URGENT: MEDICAL DEVICE CORRECTION

StealthStation™ Cranial and Synergy™ Cranial Depth Gauge Inaccuracy

29 October 2018

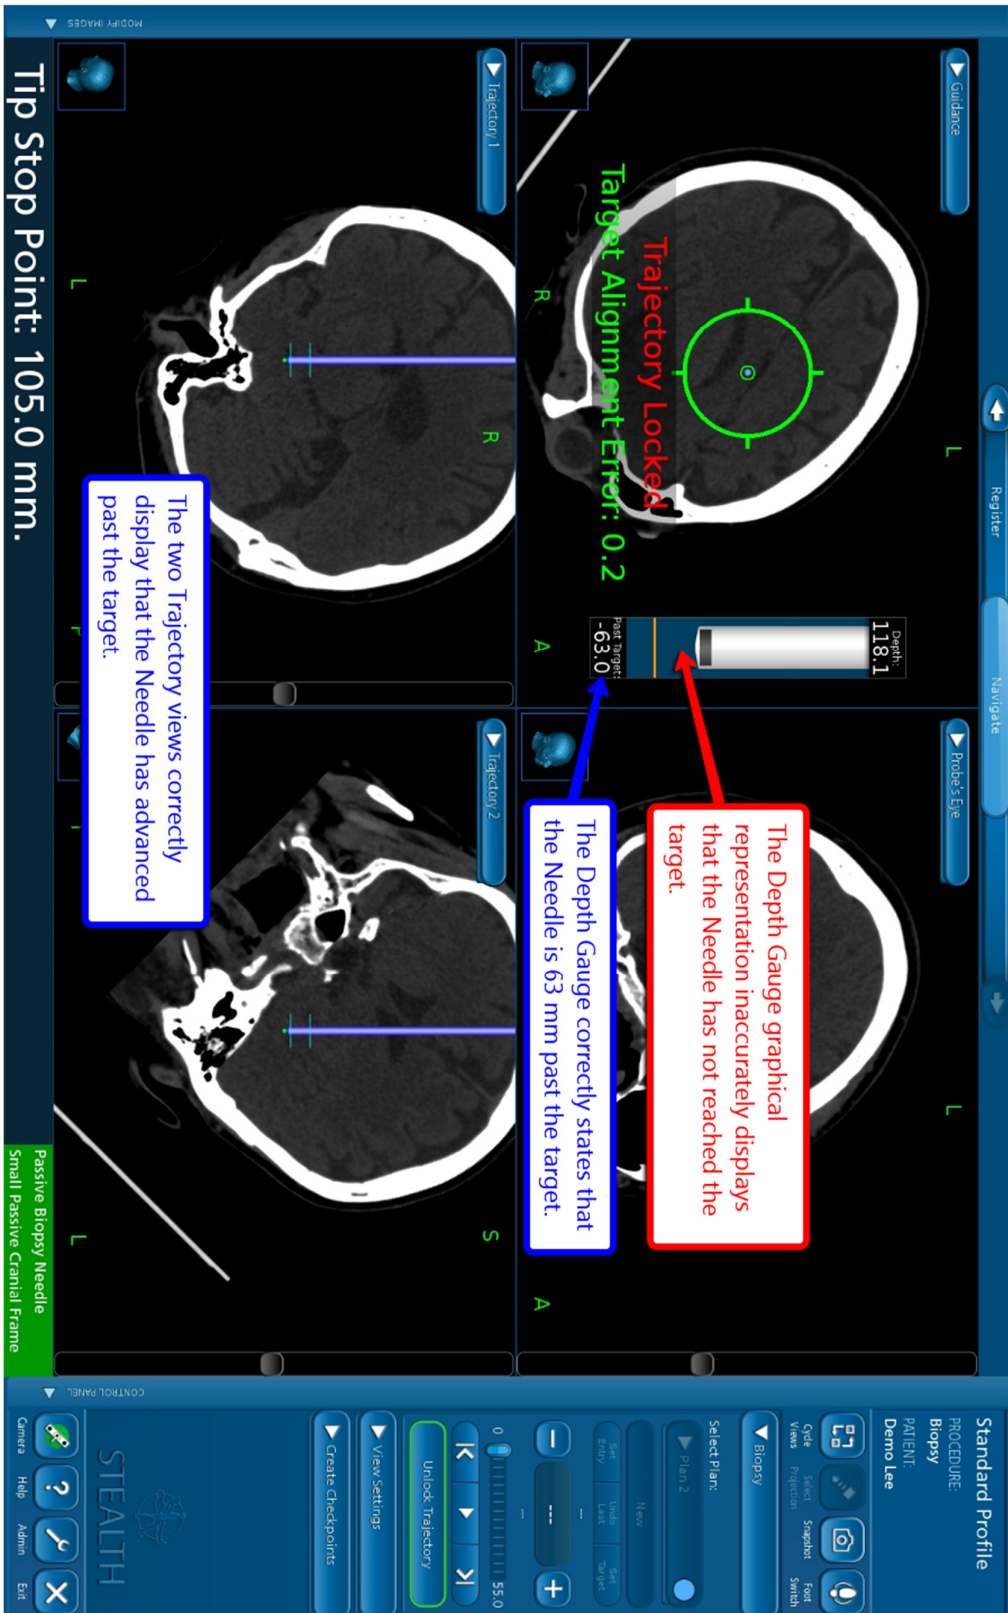
The image on page two contains an example of the error use case. All views correctly show that the instrument is past the target, and the Depth Gauge correctly displays the past-target measurement of -63, which indicates the instrument tip has advanced 63 mm beyond the intended target. However, the graphical Biopsy Needle cut window appears not to have advanced to the target position.

The two Trajectory views correctly display that the Needle has advanced past the target.

The Depth Gauge correctly states that the Needle is 63 mm past the target.

The Depth Gauge graphical representation inaccurately displays that the Needle has not reached the target.

- Do not set a projection longer than the length of the surgical plan.
- Per the Cranial Software Pocket Guide, always use the Biopsy Needle Mechanical Depth Stop.
- Ensure *Navigate Instrument Tip* setting is selected prior to locking the trajectory and subsequently navigating the instrument (see image below).
